April 23, 1987  
ST-HL-AE-2113  
File No.: G9.17  
10CFR50

South Texas Project  
Units 1 and 2  
Docket Nos. STN 50-498, STN 50-499  
FSAR Revisions Concerning  
Appendix 7A.S

Attached are general revisions to FSAR Appendix 7A.S "Supplement to NUREG-0737", which incorporate a number of editorial corrections as well as minor technical clarifications to provide consistency with the South Texas Project Electric Generating Station (STPEGS) Emergency Plan.

Figure 7A.S.8-5

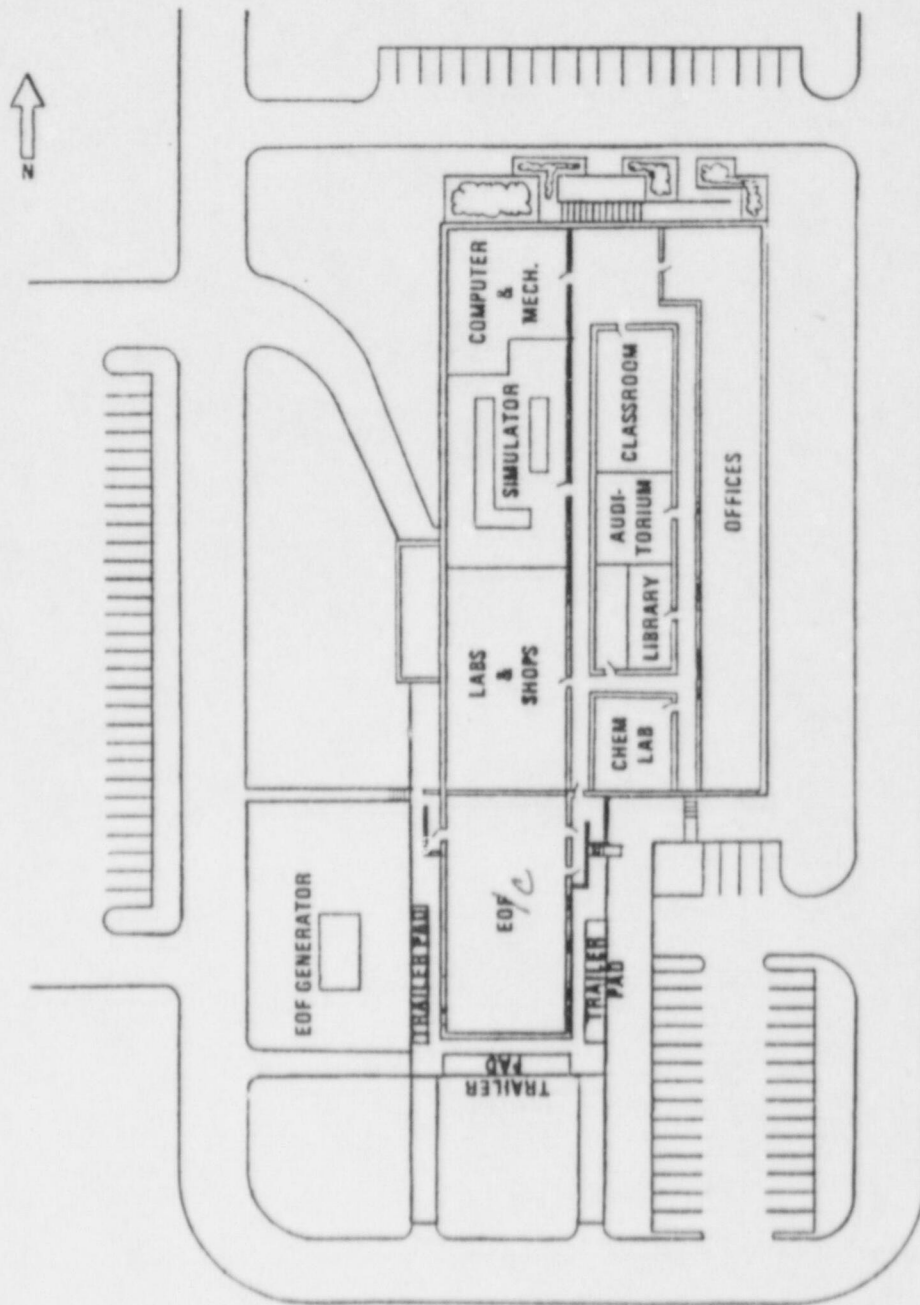
A. The EOC is a separate facility located approximately 0.5 mile east of the power block adjacent to the training/simulator building and linked to this building by an enclosed corridor (see Figures 7A.S.8-5 to 7A.S.8-7).
